**MONTGOMERY COUNTY HISTORIC PRESERVATION COMMISSION**  
**STAFF REPORT**

<b>Address:</b>	2 East Kirke St., Chevy Chase	<b>Meeting Date:</b>	9/5/2018
<b>Resource:</b>	Non-Contributing Resource <b>Chevy Chase Village Historic District</b>	<b>Report Date:</b>	8/29/2018
<b>Applicant:</b>	Andrew Umhau	<b>Public Notice:</b>	8/22/2018
<b>Review:</b>	HAWP	<b>Tax Credit:</b>	N/A
<b>Case Number:</b>	35/13-18AA	<b>Staff:</b>	Michael Kyne
<b>PROPOSAL:</b>	Fence replacement

SITE  
 PLAN

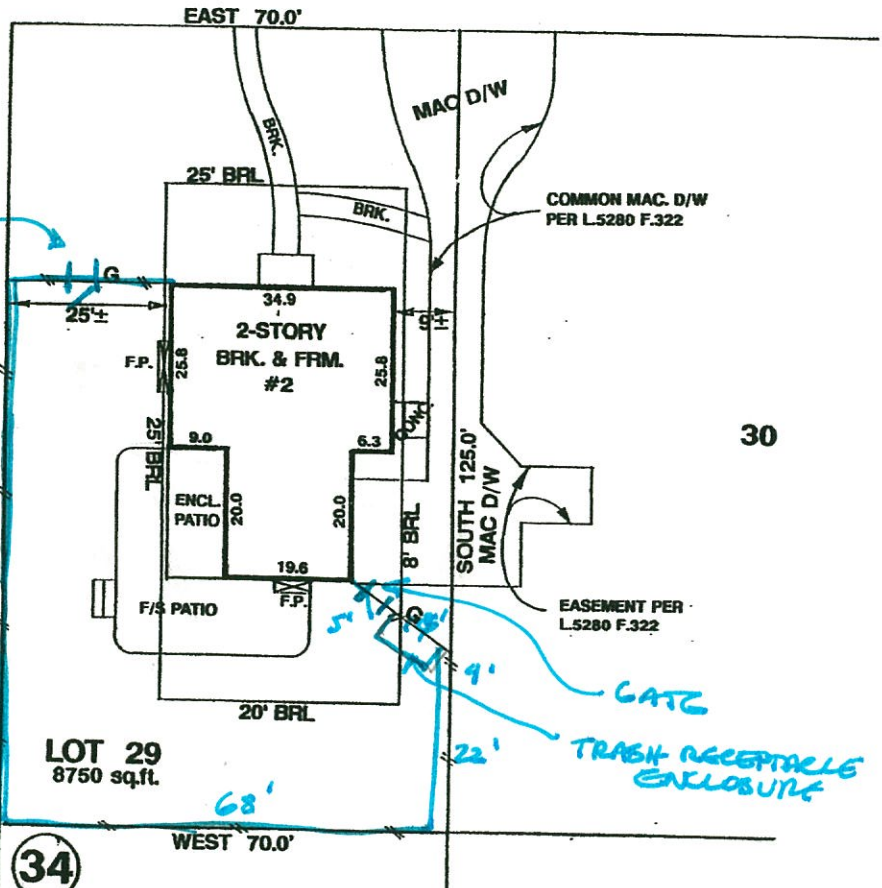
The subject property is a c. 1927-1941 Colonial Revival-style Non-Contributing Resource within the Chevy Chase Village Historic District. The property is on a corner lot, with its front (north) facing East Kirke Street and its right side (west) adjacent to Connecticut Avenue. There is an existing 6' tall wooden stockade-style fence at rear, left side (east), and right side (west) of the property. The fence on the left side (east) terminates at the rear of the house, while the fence on the right side (west) continues to the approximate front of the house, with a return to the right/front (northwest) corner of the house. The return is parallel to East Kirke Street and is highly visible from the public right-of-way. The applicants propose to replace the existing fence with a 6' tall wooden flatboard fence in the same location.

The Commission's fence policy requires fences forward of the rear plane of houses within historic districts to be no taller than 4' with an open design, preserving the open streetscape. Fences beyond the rear plane are allowed at a maximum height of 6'-6".

Staff finds that the proposed fence should conform to the Commission's fence policy to ensure that the proposal does not detract from the character-defining features of the historic district or surrounding streetscape. Staff recommends that the HPC approve the applicants' proposal, with the condition that the fence at the front (north) and right side (west) will be reduced to 4' in height and be an open picket-style fence to the approximate rear plane of the house, or that the proposed 6' tall fence will be relocated to the rear plane of the house at the front (north) and right side (west), with final review and approval delegated to staff.

- 1. The fence at the front (north) and right side (west) will be reduced to 4' in height and be an open picket-style fence to the approximate rear plane of the house, or that the proposed 6' tall fence will be relocated to the rear plane of the house at the front (north) and right side (west), with final review and approval delegated to staff.**
